YK 510 xx 3 x x 00G

TITLE	YK-510 With Flange Series				
PART NO.	YK510xx3xx00G			DWG NO.	8YK0001-510
APPROVED	CHECKED	DESIGNED	DRAWN	CUST NO.	
		Jacky 2012.10.24	Jacky 2012.10.24	SHEET: 01/01	UNIT: mm SCALE: NONE REV.: D

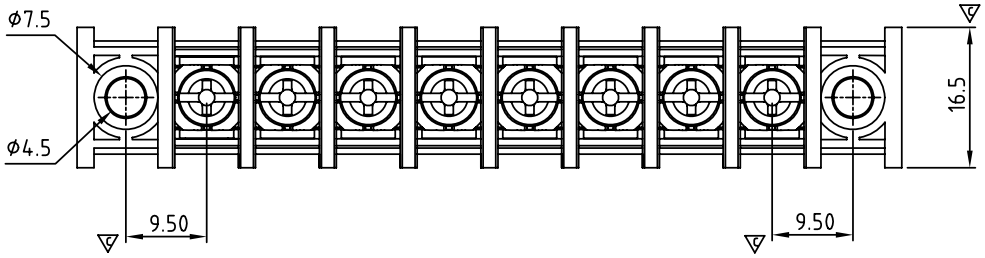
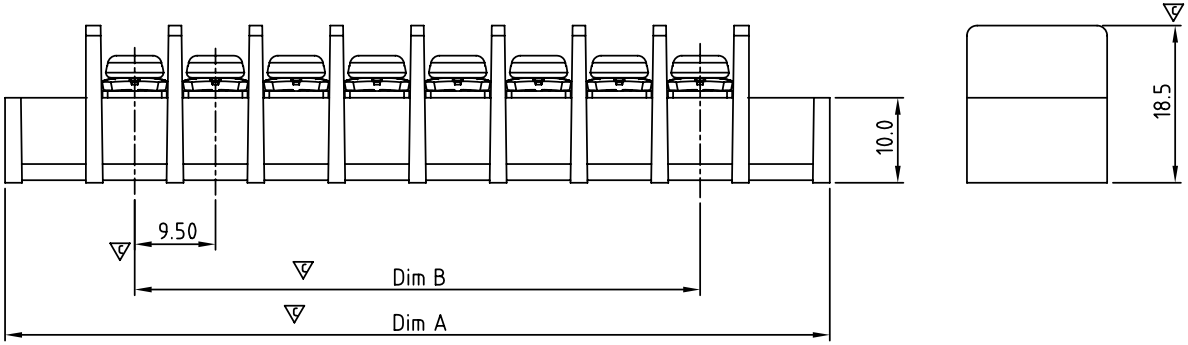
SIGN	DATE	DESCRIPTION	APPROVER
1	09/05/26	Voltage & Current changed from 300V,25A to 300V,30A	Eris
2	09/05/26	wire range changed from 22-14 AWG to 10-22 AWG	Eris
3	09/05/26	add Safety Approval	Eris
4	10/24'12	Change the screw plating specification	Jacky
5	10/24'12	Change the dimensional tolerance	Jacky

1 RATED VOLTAGE & CURRENT:	300 V, 30A
WITHSTAND VOLTAGE:	AC 2000 V/Min
INSULATION RESISTANCE:	1000 MΩ OR MORE AT DC 500 V
OPERATING TEMPERATURE RANG:	-40 °C ~+115 °C
SCREW TORQUE VALUE:	8.8 Lb-In.
2 WIRE RANGE:	10-22 AWG
1) MOLDED PARTS:	Thermoplastic, UL 94 V-0 BLACK
2) TERMINAL:	BRASS, 0.8t, Tin PLATED
4 3) TERMINAL SCREWS:	STEEL, M3.5
3 APPROVAL: (c UL us) PENDING

TERMINAL & SCREW PLATED
- 0: TERMINAL & SCREW: G/F
- 4 1: TERMINAL: G/F, SCREW: Zinc
- 2: TERMINAL: Sn, SCREW: G/F
- 4 3: TERMINAL: Sn, SCREW: Zinc

DimensionA&B	Tolerance
>6~30	±0.30
>30~120	±0.40
>120~400	±0.60
